Subject: additional comments

Hi IPC, my additional comments are attached.

Setbacks and Buffers

Fig. 8. Air temperature difference as a function of distance from the perimeter of the solar farm. Negative distances indicate locations within the solar farm.

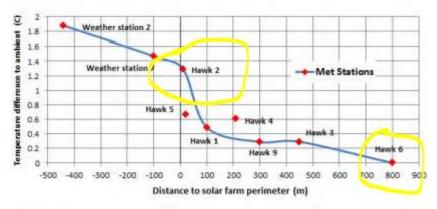
I note that DPE is now suggesting a Heat Island setback of a least 30m, this continues to be unsatisfactory given

- An at least 30 setback is yet to be scientifically proven as a full mitigation of Heat Island
 offects
- DPE has failed to mention in their response that a 30m setback is only potentially effective
 when employed with a visually dense vegetation buffer higher than the top of the PV array at
 its highest point.

- In his report to the Greater City of Shepparton, Mr Ken Guthrie states in point 95, "In my opinion a dense vegetation buffer will effectively stop heat transmission to neighbouring properties. There will be minimal effect on temperatures more than 100m from the outside of the vegetation." Whilst there may be some linkage between this statement and Fthenakis and Yu, given the study was done without a visually dense vegetation buffer and temperatures in the study did decline the most at 100m, Mr Guthrie has not provided a rationale, linkage or evidence between Fthenakis and Yu, his point 95, and his later recommendation in point 101 for a setback approximately 30 metres from the boundary. Minimal effect on temperatures more than 100m from the outside of the vegetation, also does not mean that the Heat Island effect is fully mitigated at 100m.

- o Initial phase at site commissioning with an 800m buffer from the panels
 - Once the hedge is effective, based on a scientific study the buffer can be reduced to an evidence based and scientifically proven buffer (perhaps > 100m)
